SERVICE BULLETIN

Models Affected: L-1X, L-1X16

Subject: IMPORTANT SAFETY WIRING INSTRUCTIONAL MESSAGE

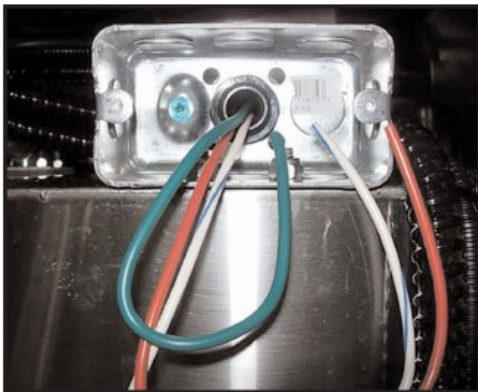
Photo shows the three wire connection point as it appears when junction box cover is removed. For machine to be wired properly, the GREEN ground wire located in the junction box must be secured to green screw grounding lug inside junction box. Caution: install a wire connector on GREEN wire and secure to the junction box provided with green ground lug screw. **Do Not** connect power cord ground or the hard wire ground directly to dishmachine provided GREEN ground wire. Doing so will bypass the proper grounding of the dishmachine.

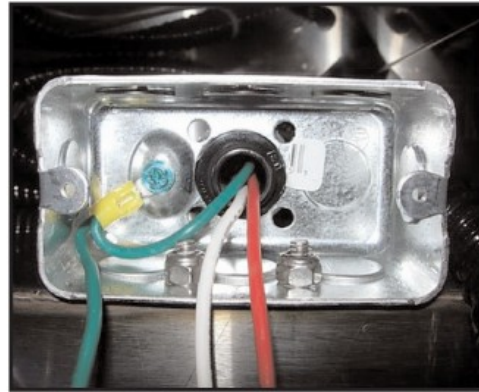
Photo shows proper grounding of the GREEN wire located inside the junction box. Connect power cord ground or hard wire ground (not shown) directly to the green screw ground lug or to the pigtail GREEN wire provided inside the junction box.
